HOSPITAL DISTRICT OVERLAY (METHODIST)

Exhibit 468C Street Hierarchy Plan

Staff's DRAFT with LCNA Recommendations - July 2014

Staff
Recommendation

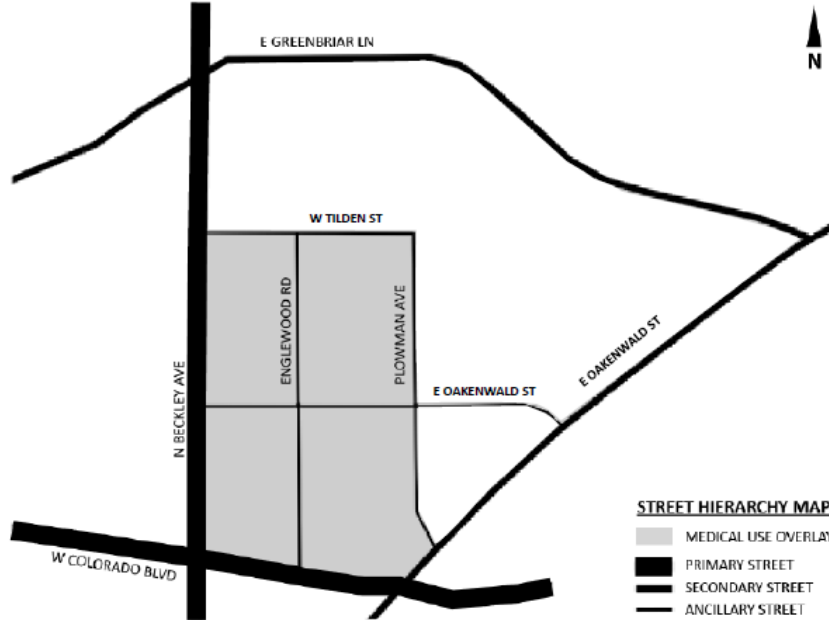
- (1) Methodist prefers boundaries of the 468C Hierarch Plan (page 1).
 - a. If the boundaries follow staff proposed street hierarchy plan, Methodist would like to expand the boundaries through a non-discretionary CPC approval process.

* Note: Texas Local Government Code requires City Council to make final decision for zoning changes, Director cannot take powers away from City Council.
